# Addendum No. 2

**PROJECT:** Vivie Nelson Care Center Renovation, Alexandria, MN

**From:** Wold Architects and Engineers

**Subject:** Addendum No. 2 for Bidding Documents for the
**Vivie**
**Nelson Care Center Renovation**
**Alexandria, Minnesota**

# A1.001a

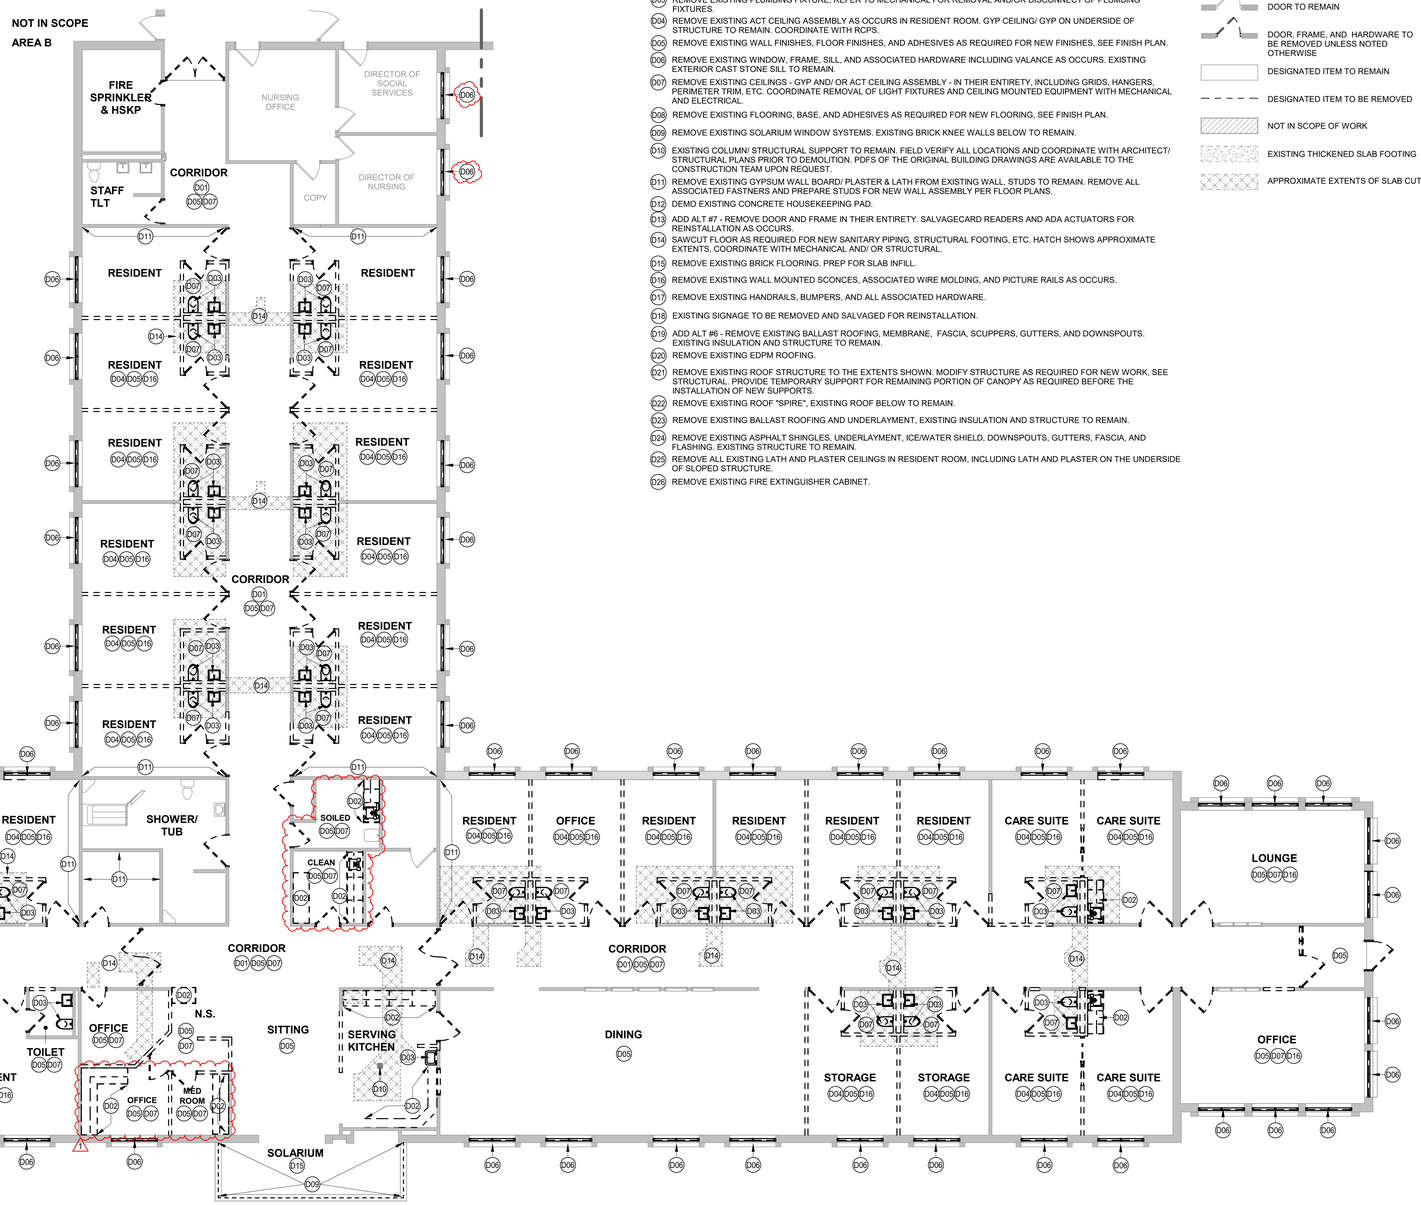
1. **DRAWING A1.00a – FIRST FLOOR DEMOLITION PLAN – AREA A**
   - A. **Reissued this addendum.**
     - i. Demolition of existing floor access panels and new opening in exterior wall as indicated.

# A1.001b

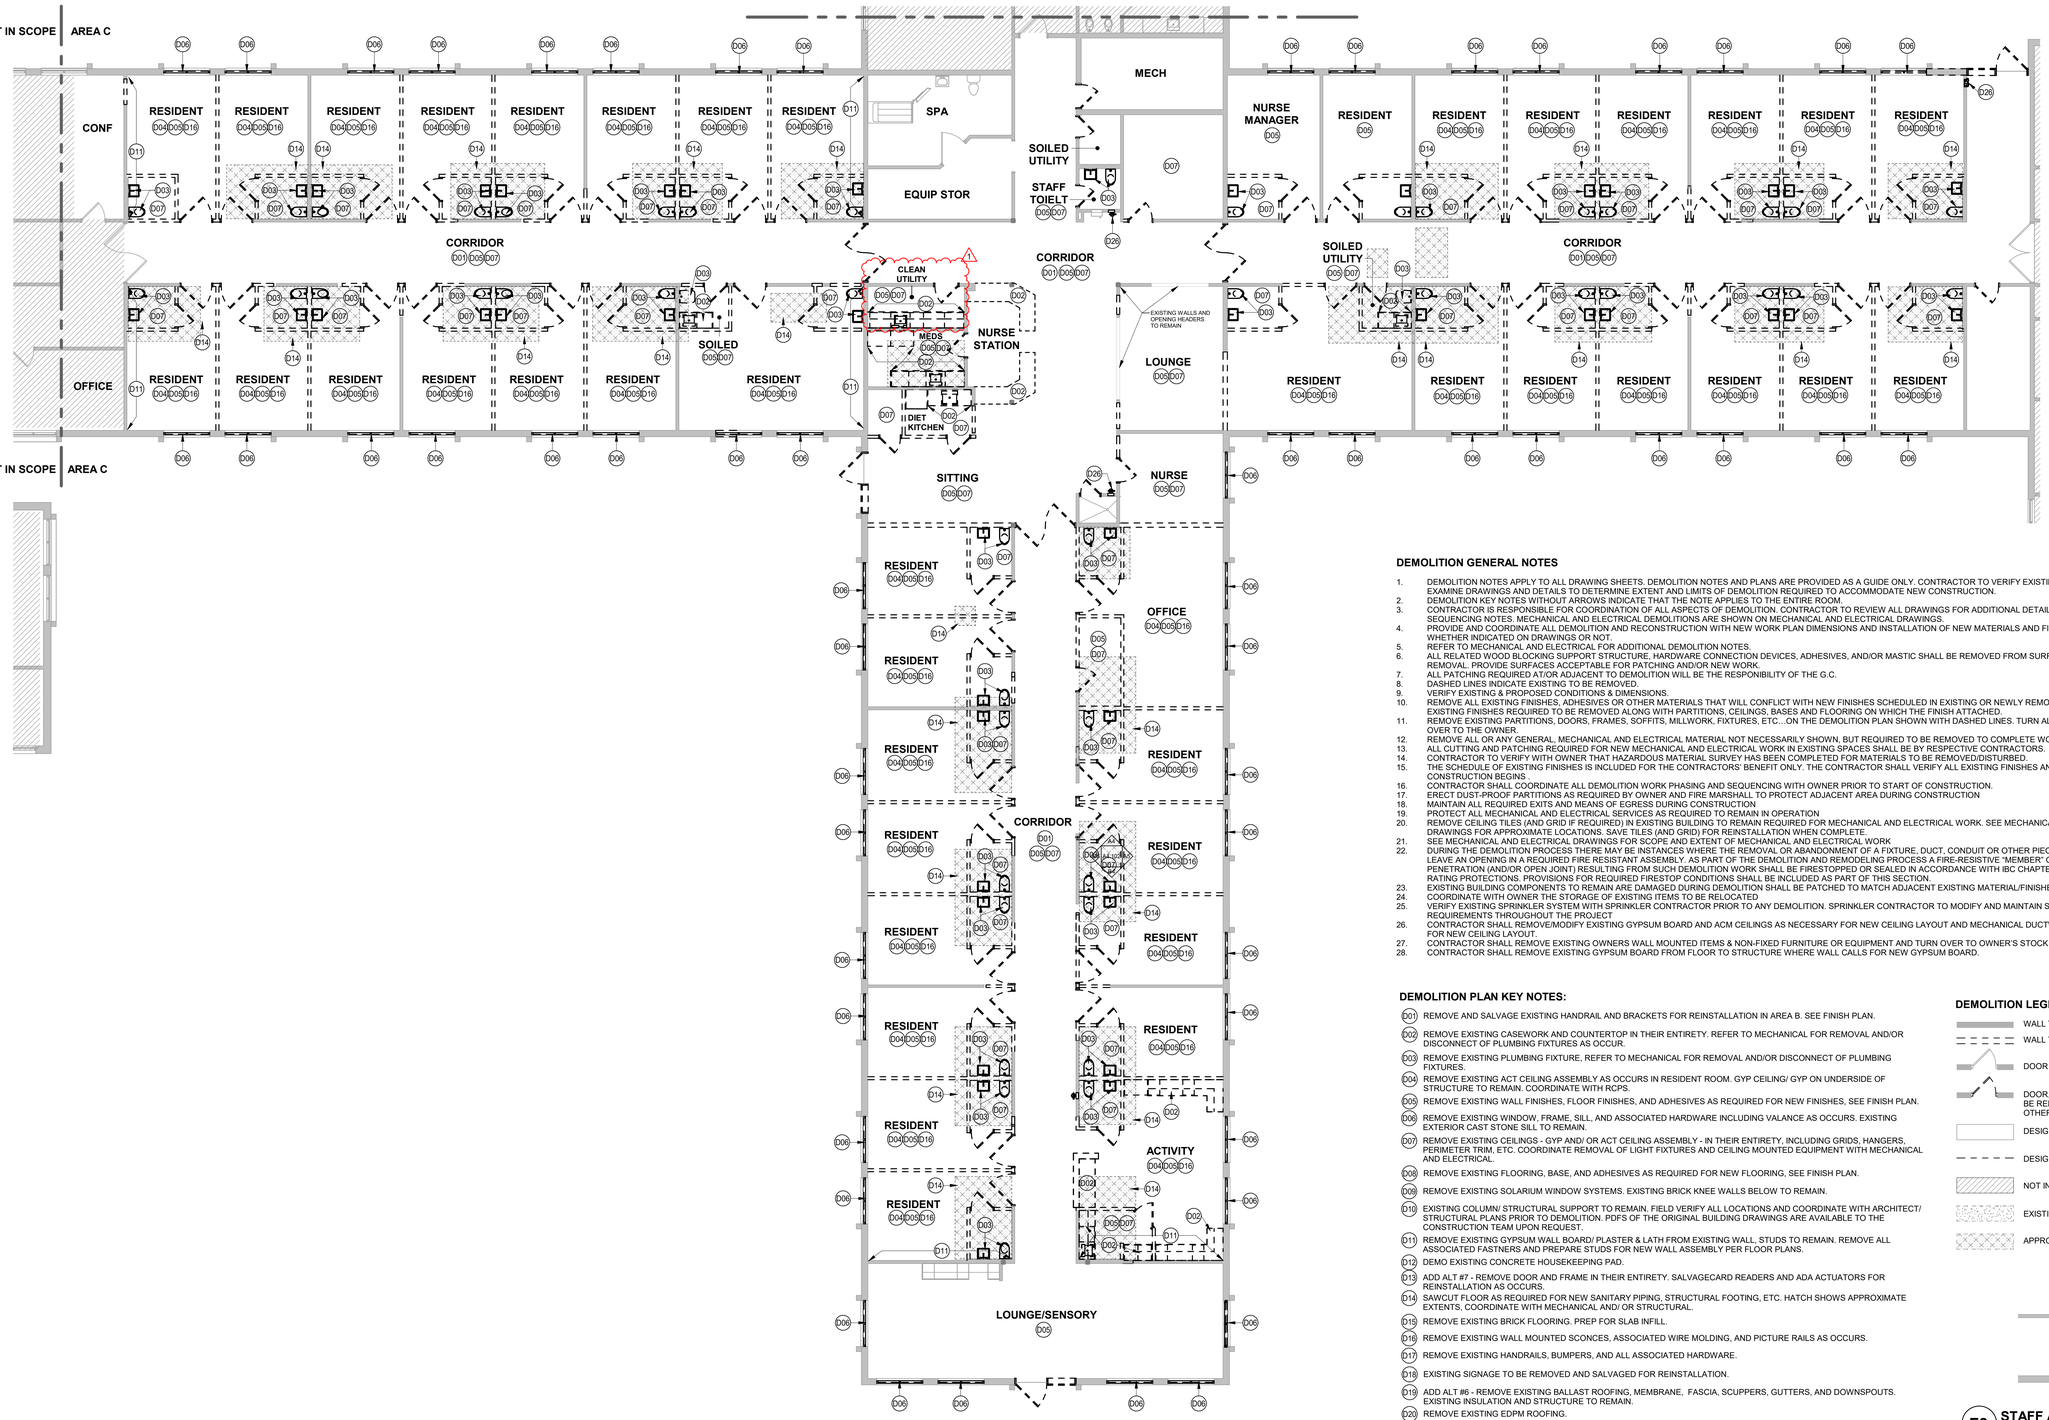
2. **DRAWING A1.00b – FIRST FLOOR DEMOLITION PLAN – AREA B**
   - A. **Reissued this addendum.**
     - i. Demolition scope shown in Clean Utility, Med room, Solid Utility, and Office.

- ii. Additional windows noted for demolition.
3. **DRAWING A1.00c – FIRST FLOOR DEMOLITION PLAN – AREA C**
   - A. **Reissued this addendum.**
     - i. Demolition scope shown in Clean Utility.

**FIRST FLOOR PLAN - AREA C - PINES**

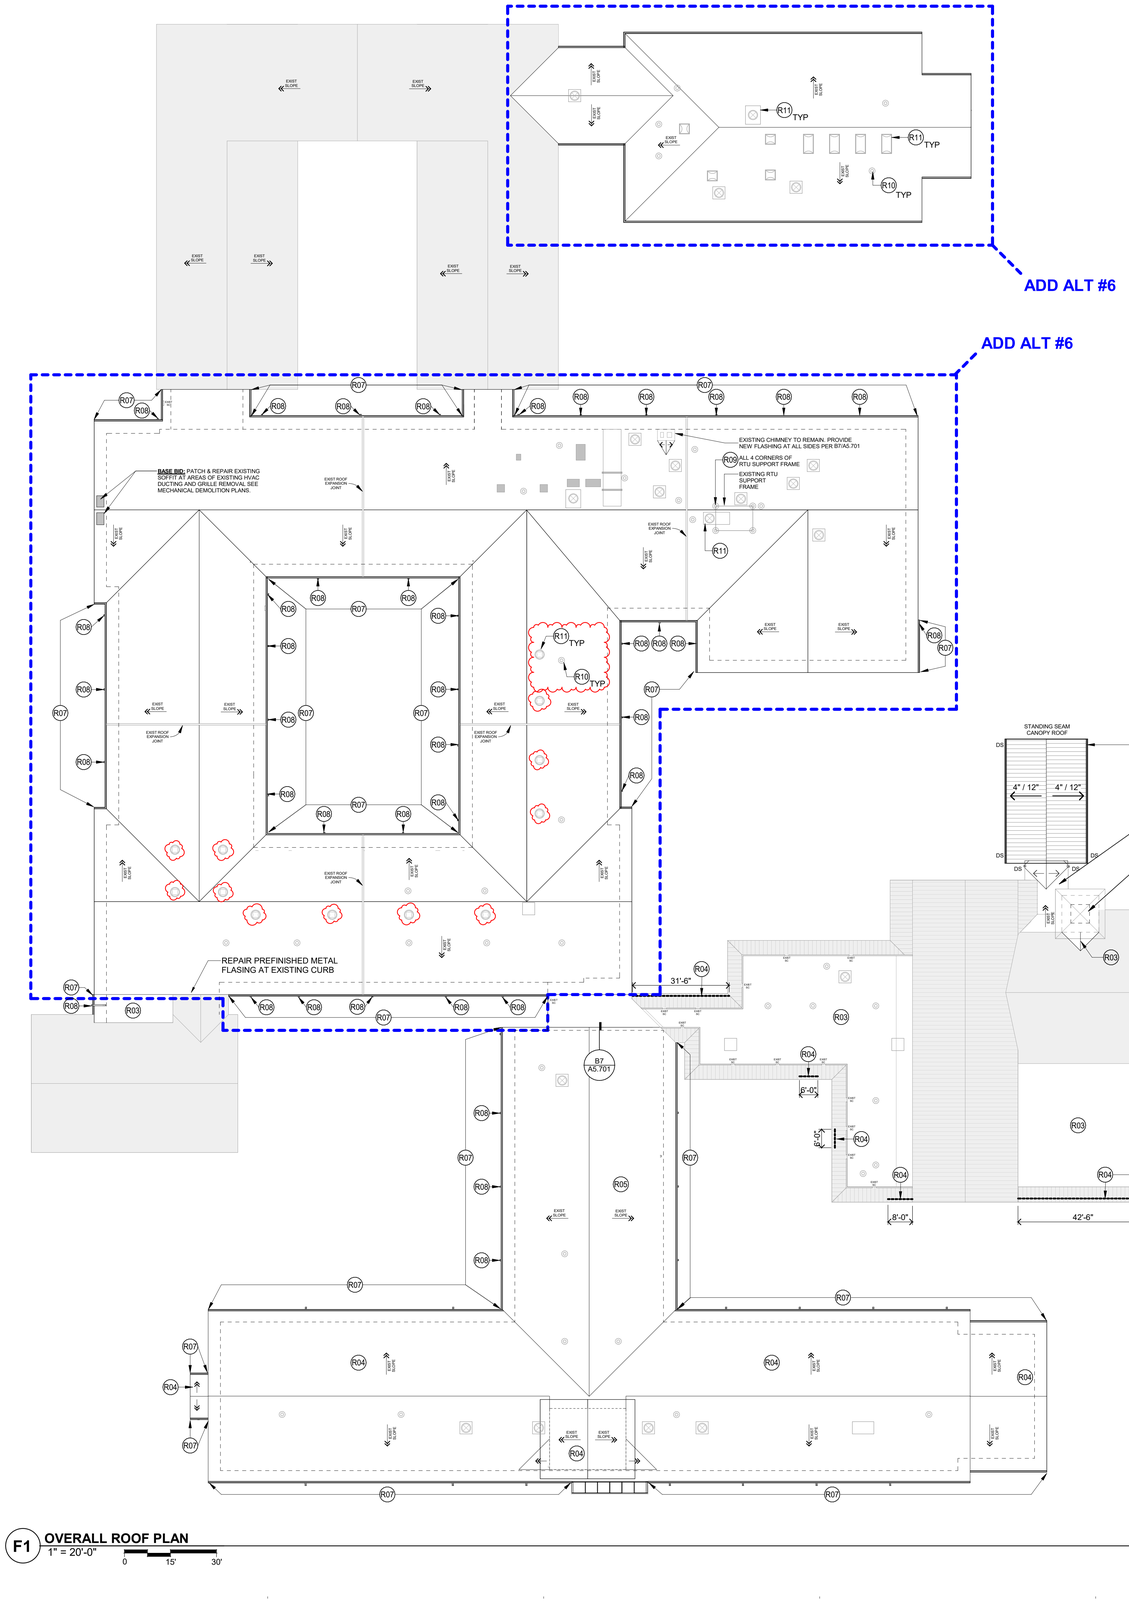
- A. **Reissued this addendum.**
     - i. Revised window and louver types at Mech C143 and Storage C145 as indicated.
     - ii. Revised window types at Nursing Office C127 as indicated.

iii. Revised Double Resident Room C134 as indicated.
iv. Added door C134B as indicated.
v. Revised Elec Panel C136 to Linen C136
vi. Revised door C136 as indicated.
vii. Added scope in Clean Utility C122.

# A4.00a

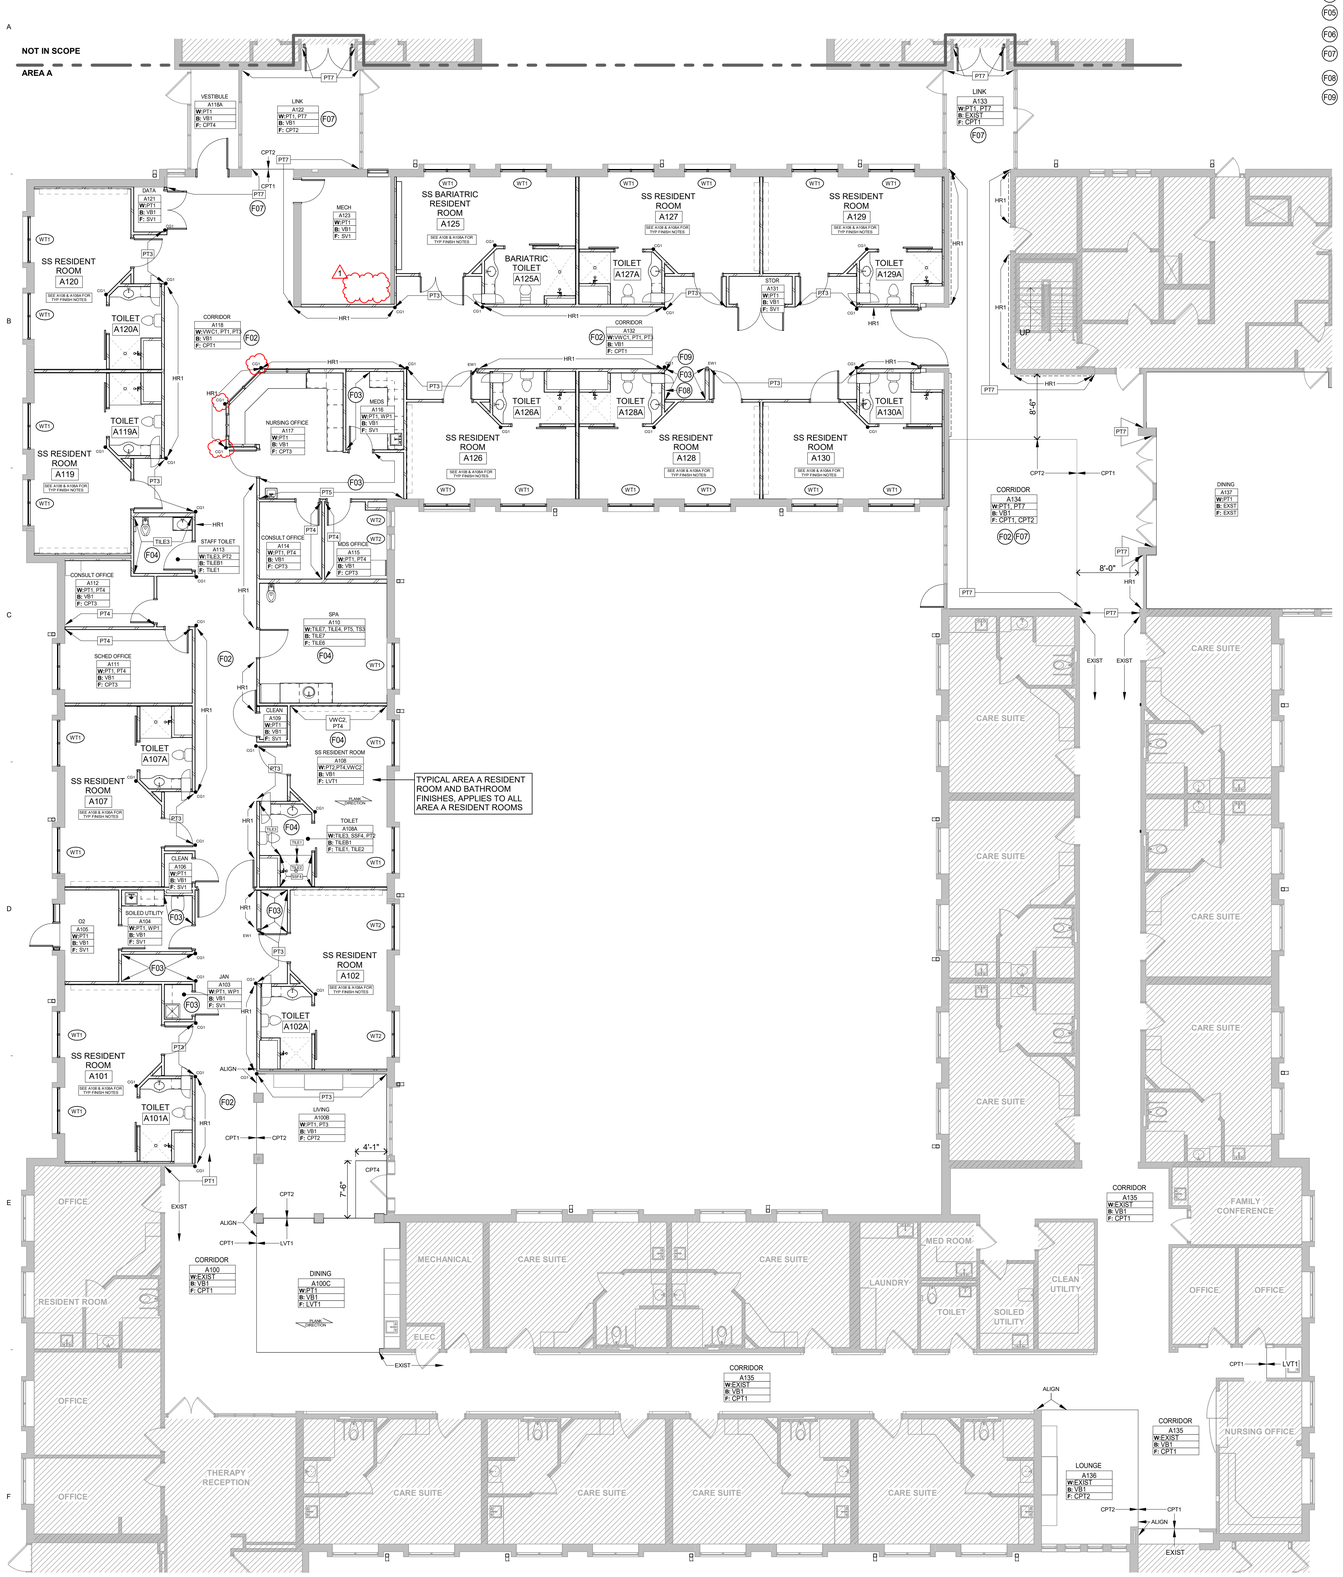
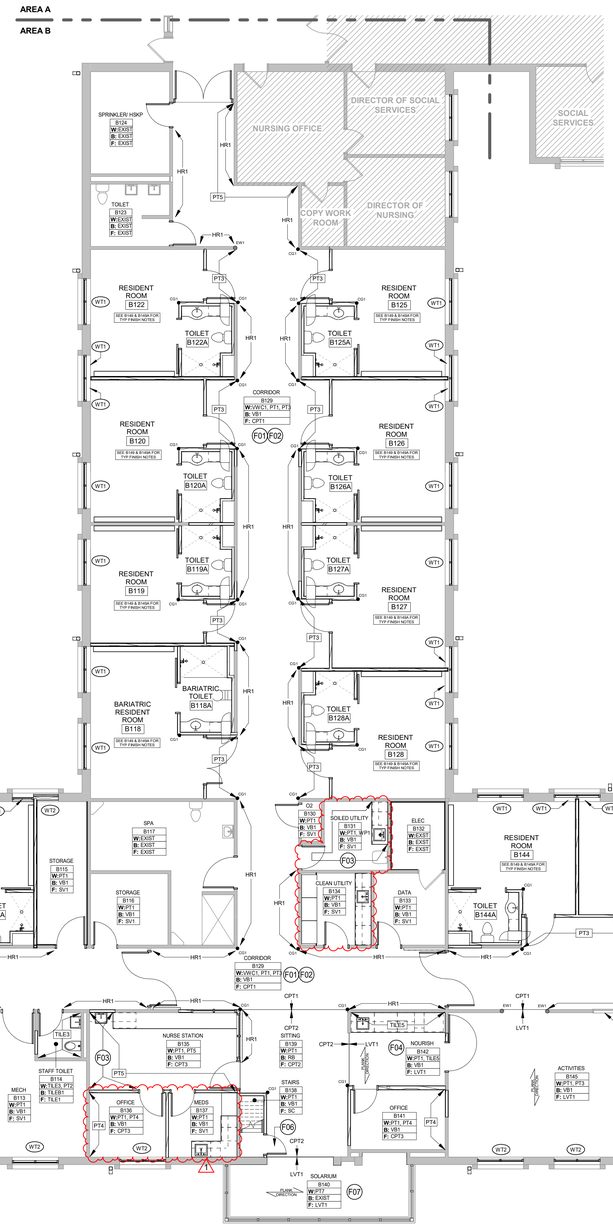
12. **DRAWING A4.00a – FIRST FLOOR FINISH PLAN – AREA A & MATERIAL ID**
    A. **Reissued this addendum.**
       i. Clarifications to Material Finish / Color Schedule as indicated.

# A4.101

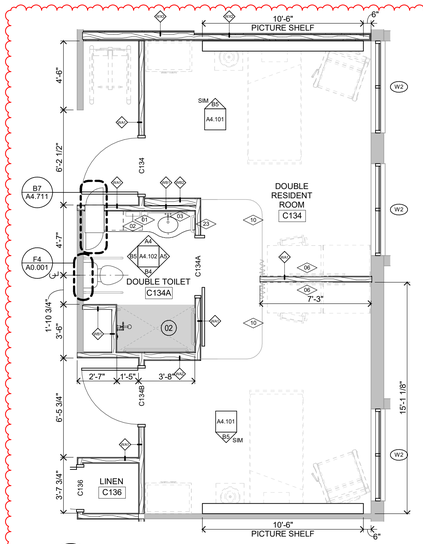
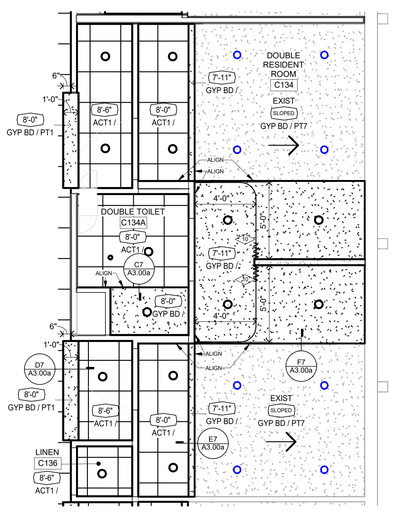
15. **DRAWING A4.101 – ENLARGED PLAN & INTERIOR ELEVATIONS**
    A. **Reissued this addendum.**
       i. Revised dimension as indicated.
16. **DRAWING A4.102 – ENLARGED PLAN & INTERIOR ELEVATIONS**
